Model 204, 207, 212, 218, 231

Modification notes

P35.10-A019-05

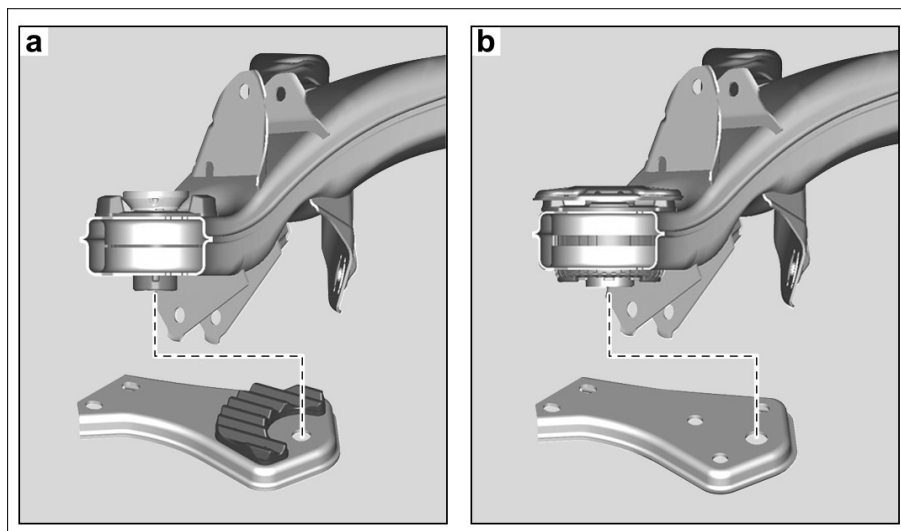
We would like to inform you that, on the vehicle model series mentioned above, the rear axle carrier and the front elastomer bearings have been optimized for individual vehicle model designations. As a result, the new stop plates (picture b) must be installed on vehicle model designations with optimized rear axle carriers and elastomer bearings.

i For this, the additional information in the XENTRY Portal Parts Information must be strictly observed during the ordering process. If no additional or changed parts are displayed, the old stop plates can be reused.

i The stop plates and rear axle carriers are shipped ready for assembly. No further conversion measures are required between old and new parts.
